TOWN OF GLASTONBURY
GL-2015-18
Transfer Station Electrical Service Upgrade

ADDENDUM NO. 1
12/18/14

REVISED SECTION 16400 – SERVICE AND DISTRIBUTION

TITLE
ELECTRICAL SITE PLAN, DETAILS, AND SCHEDULES

EQUIPMENT LAYOUT ELEVATION
NTS

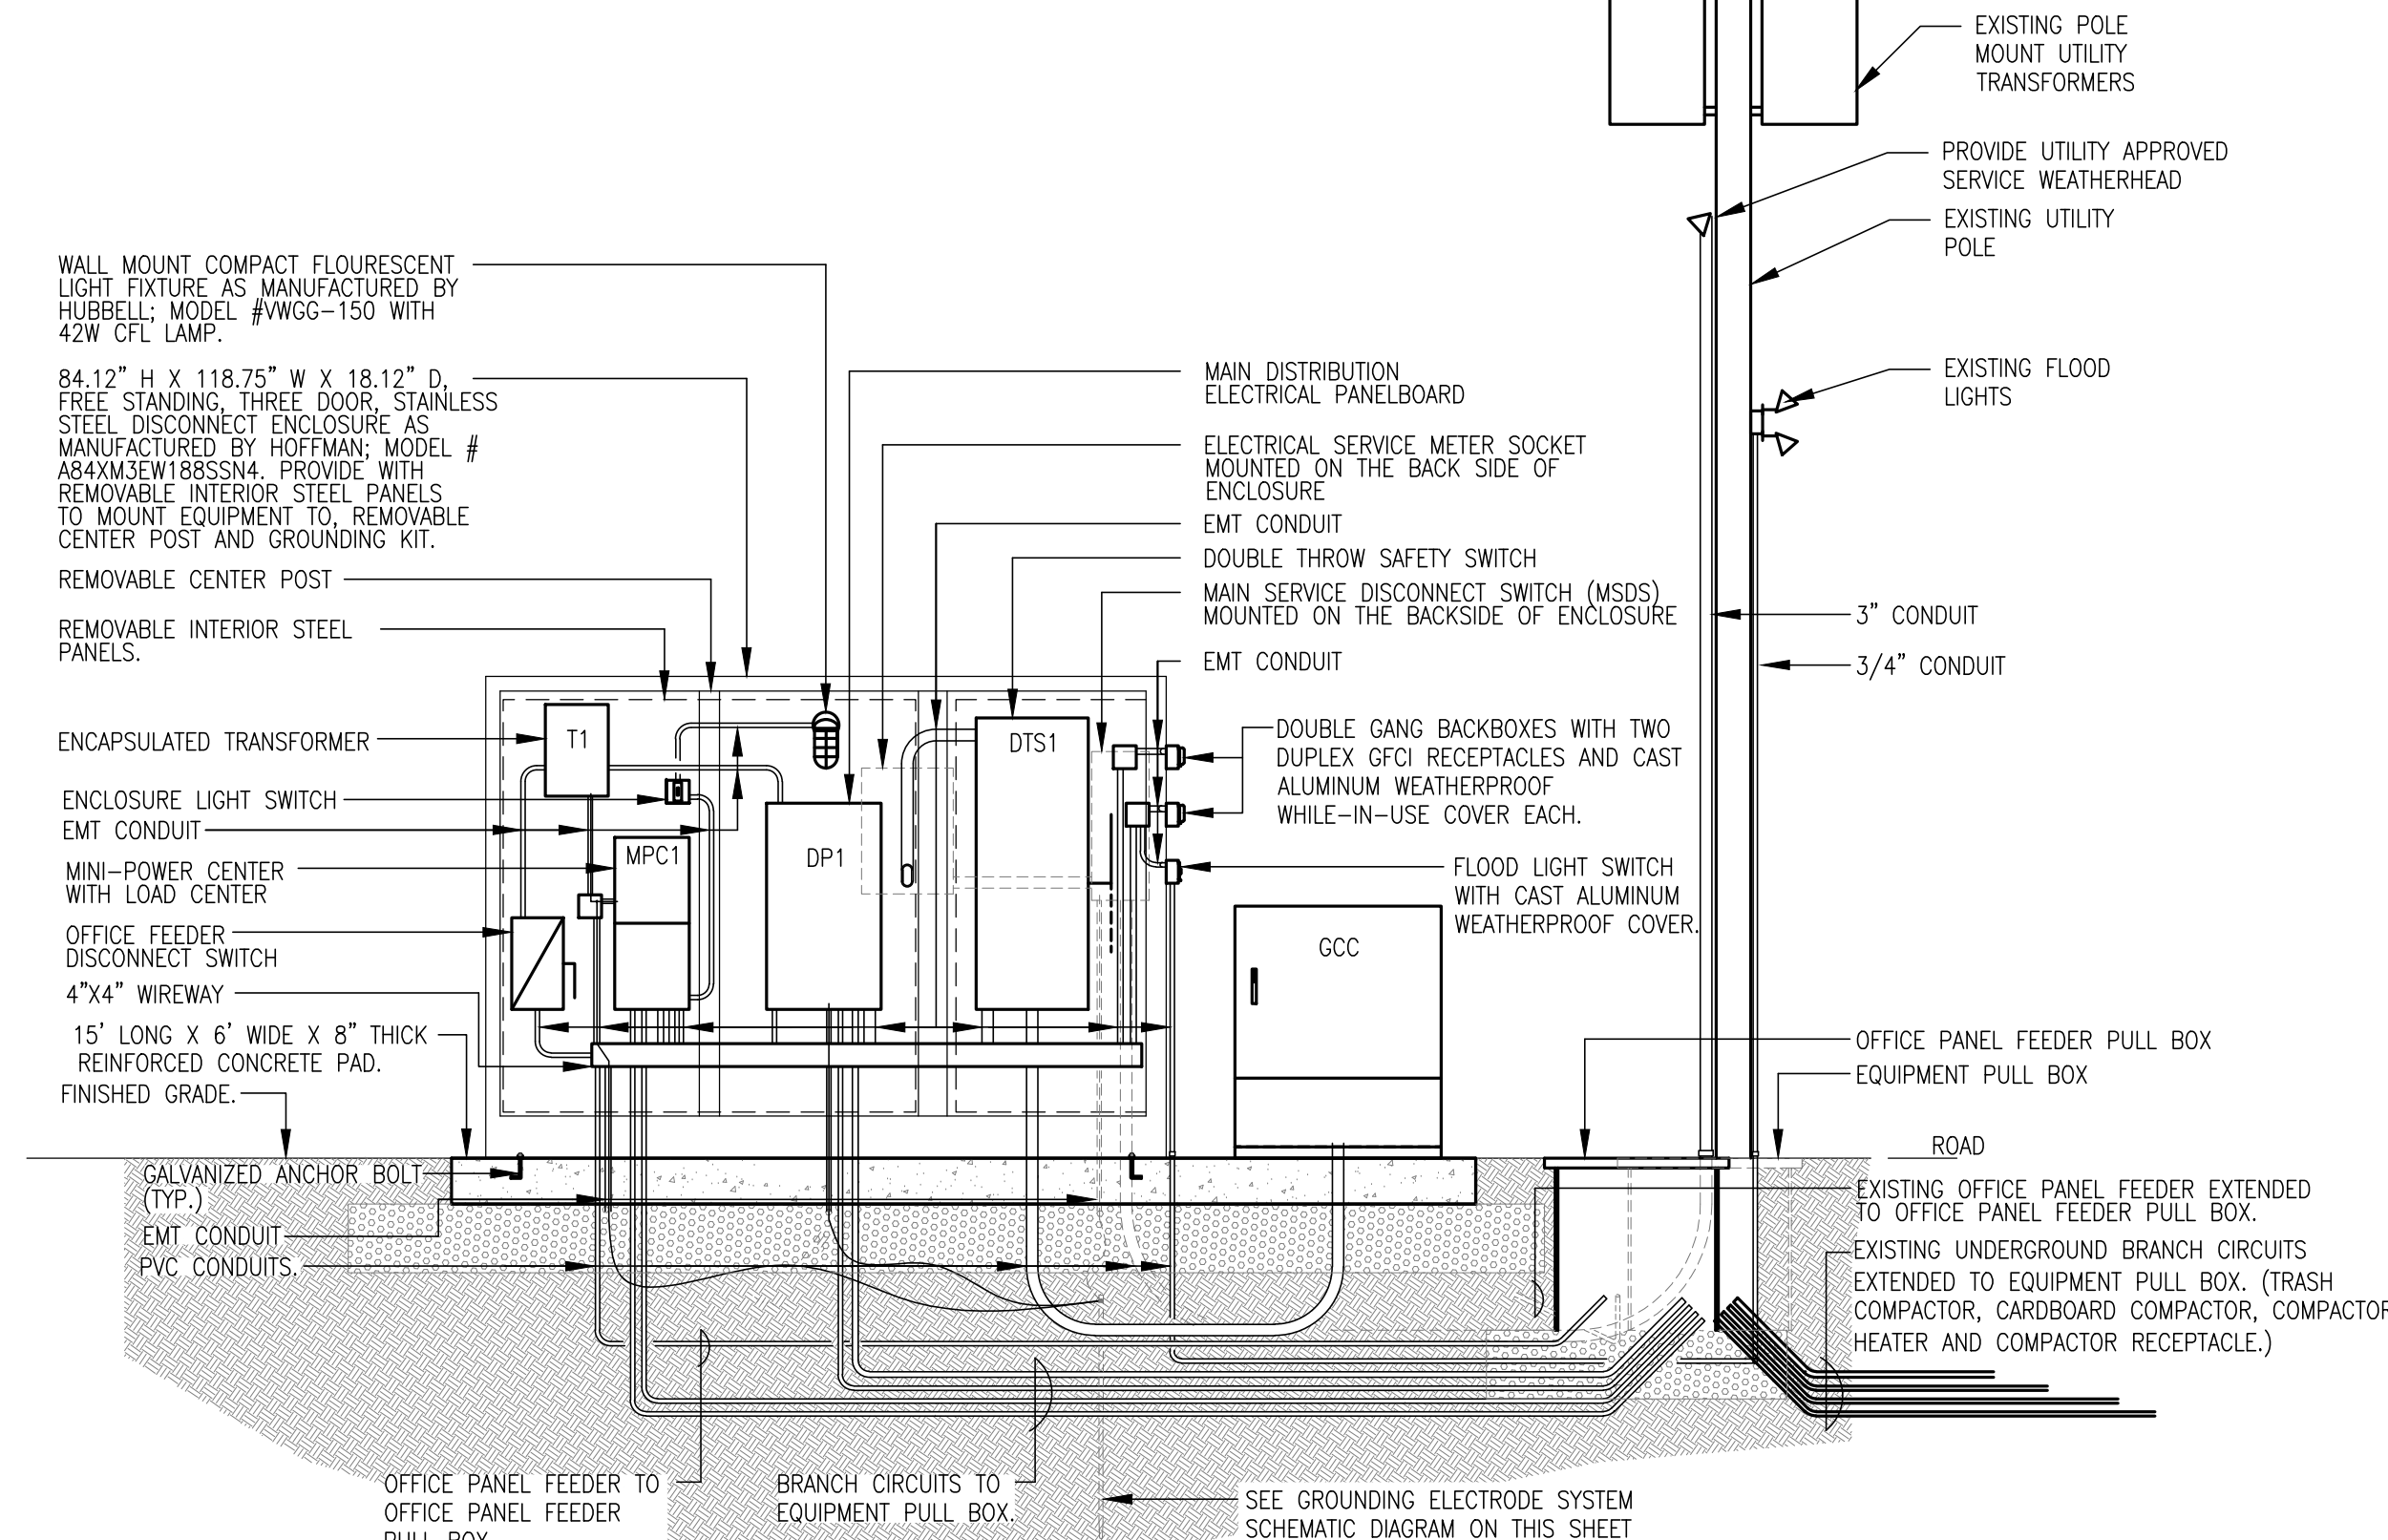
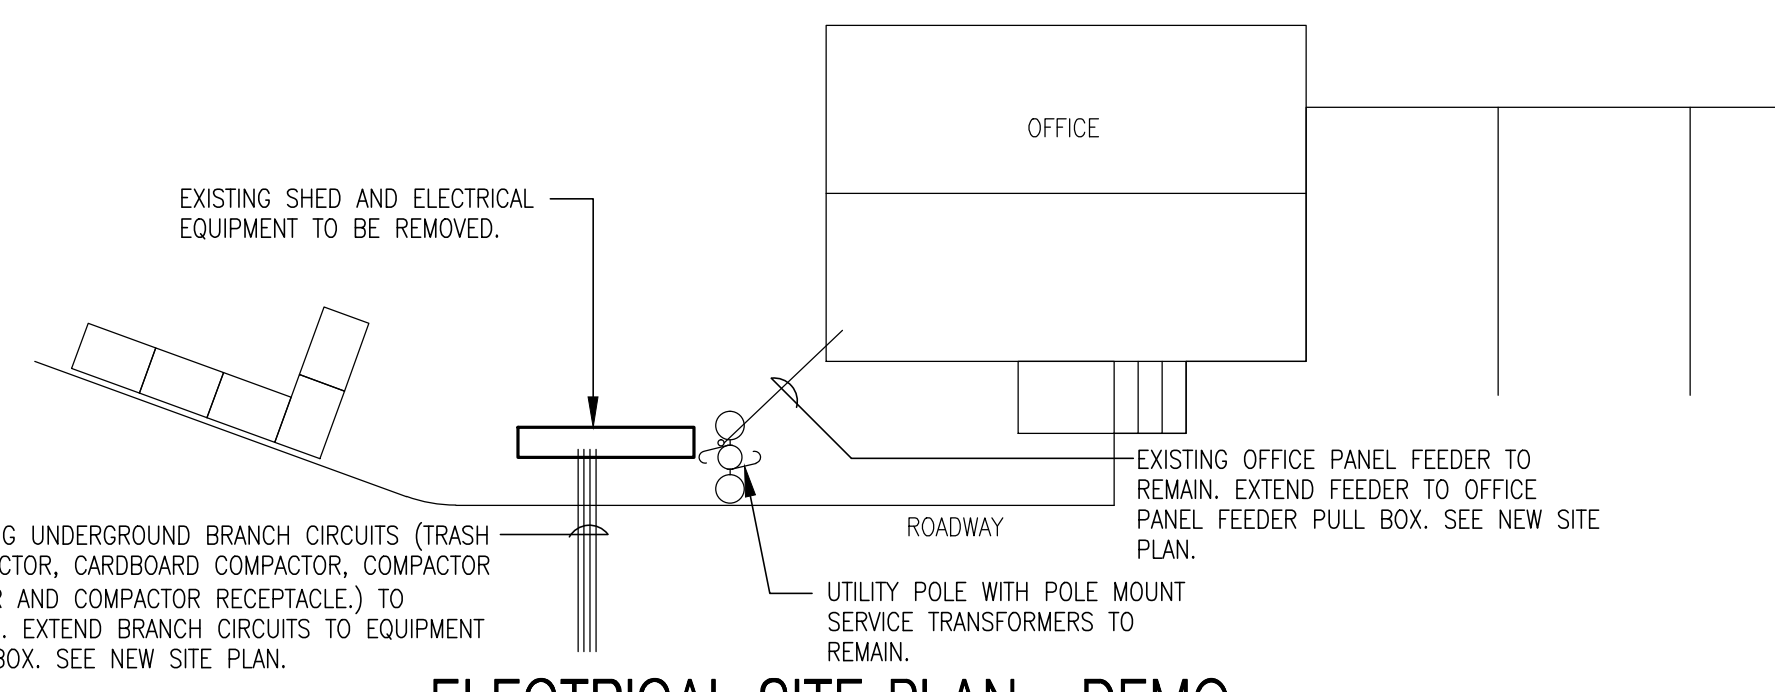
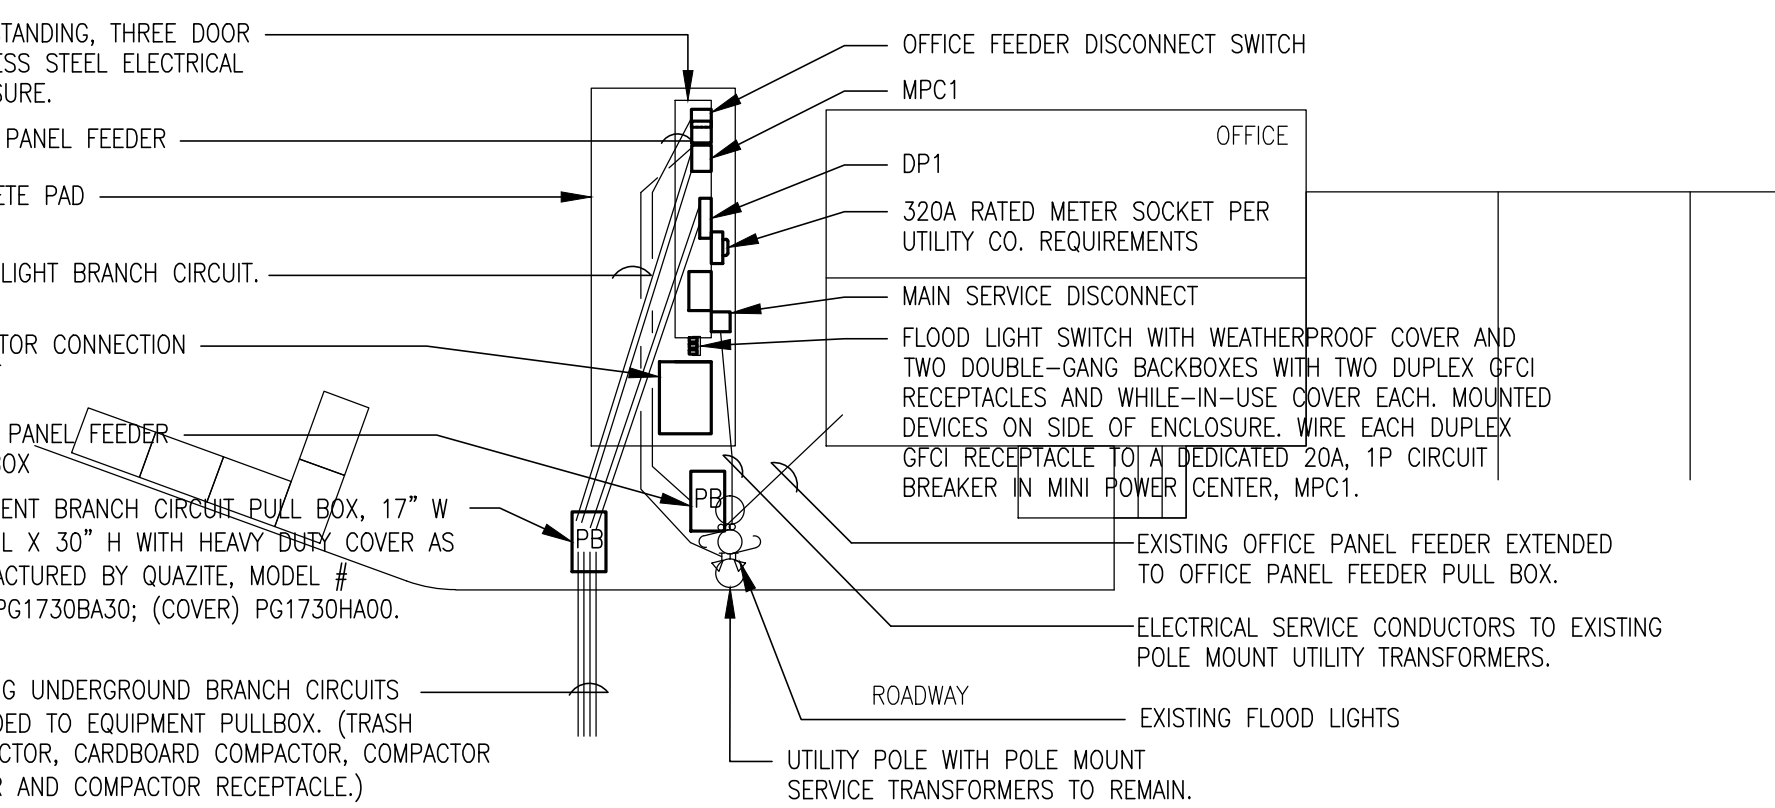
- **Replace:** Specification Section 16400 with the attached **REVISED** Section 16400 in its entirety.
- **Replace:** Drawing E-1 with the attached **REVISED** Drawing E-1

REVISIONS
 ADDENDUM #1 - ELECTRIC SERVICE AND DISTRIBUTION REVISIONS.
 12/18/14 - ADDENDUM ELECTRIC SERVICE AND DISTRIBUTION REVISIONS.
